SUBJECT: SEQUOYAH NUCLEAR PLANT – NRC OPERATOR LICENSE
EXAMINATION REPORT 05000327/2016301 AND 05000328/2016301

FACILITY POST-EXAMINATION COMMENTS AND NRC RESOLUTIONS

Item #1: Administrative Job Performance Measure (JPM C); "Align ECCS & CS Pumps to the Containment Sump with a Failure of a Containment Sump Valve."

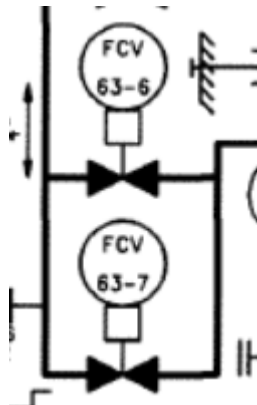
During performance of JPM C, an applicant failed to open FCV-63-7, "RHR Supply to SI pump suction." In the original version of the JPM, at JPM step 19, the applicants were expected to open BOTH FCV-63-6 **AND** FCV-63-7 per step 11 of the procedure as noted below. This step was marked as CRITICAL due to the belief that both valves were required to provide suction flow from the RHR pumps to the suction of the SI pumps. After a review of ES-1.3 "TRANSFER TO RHR CONTAINMENT SUMP" and drawing 47W811 sheet 1, it was confirmed that both FCV-63-6 and FCV-63-7 RHR Supply to SI pumps suction are in parallel. Therefore, opening either valve provides flow from the RHR pumps to the SI pumps suction. Sequoyah requests the wording for the critical step on JPM step 19 be changed to open EITHER FCV-63-6 **OR** FCV-63-7.

The licensee's recommendation to modify the wording of the critical step for JPM step 19 to "open EITHER FCV-63-6 OR FCV-63-7" is accepted. A review of drawing 47W811 sheet 1 verified that FCV-63-7 and FCV-63-6 are in parallel:

Therefore, opening only one of the valves would still provide a suction path to the SI pumps and allow for successful completion of the task.
